MIL "ON" DTC P2440/P2442

Service Category Engine/Hybrid System

Section Emission Control

YEAR(S)	MODEL(S)	ADDITIONAL INFORMATION
2014 - 2016	GX460

Figure 1. Location of Authorized Modification Label for 2014 – 2016 GX 460

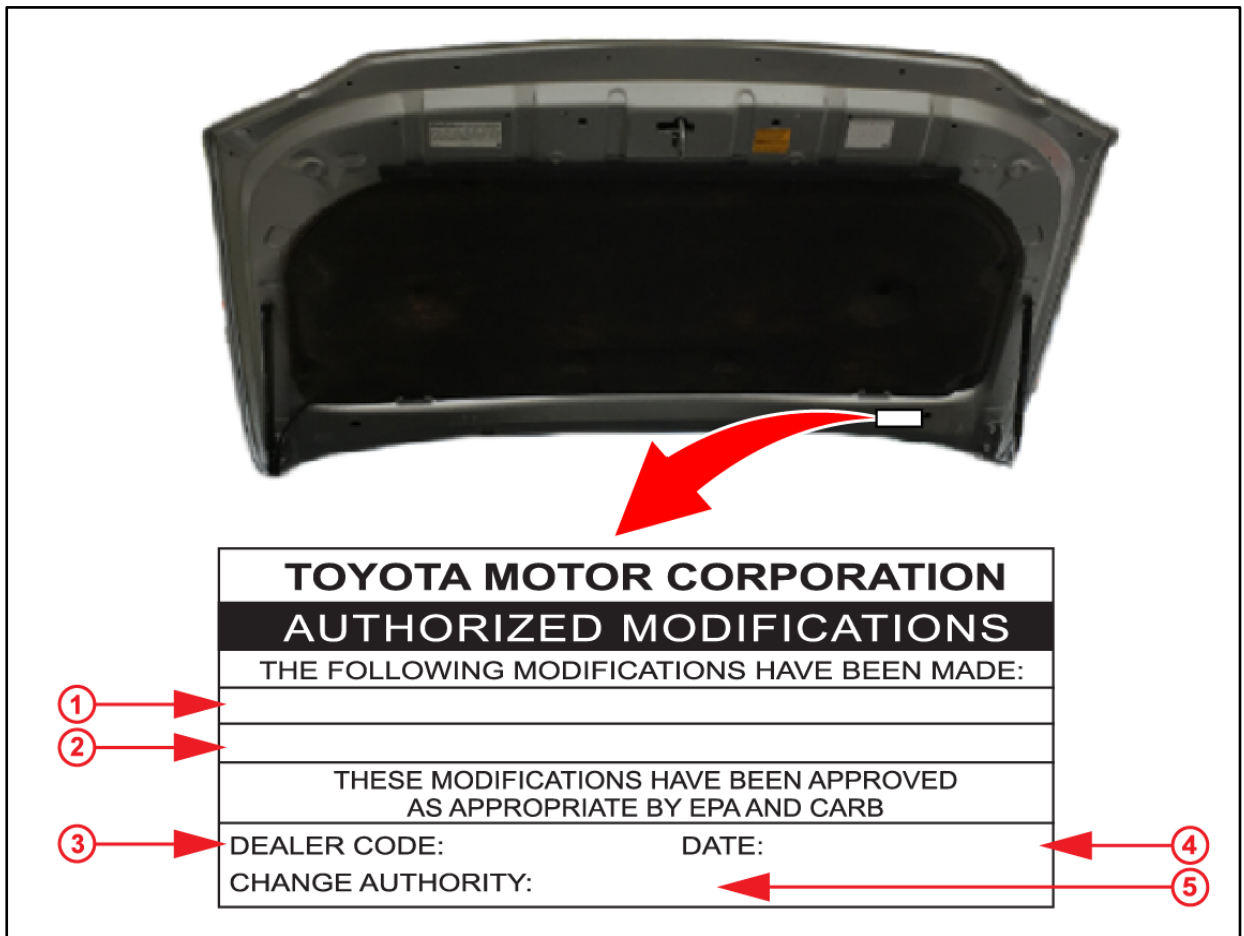
- Check for the Authorized Modification Label affixed to the vehicle in the location shown below. Confirm the ECM (PCM) calibration has been updated.

1	Replacement ECM (PCM) Part Number (i.e., 89661-60W12 or 89661-60U21)
2	New Calibration ID (i.e., 360Q9200 or 360X8100)
3	Dealer Code

4	Date Completed
5	This SB Number
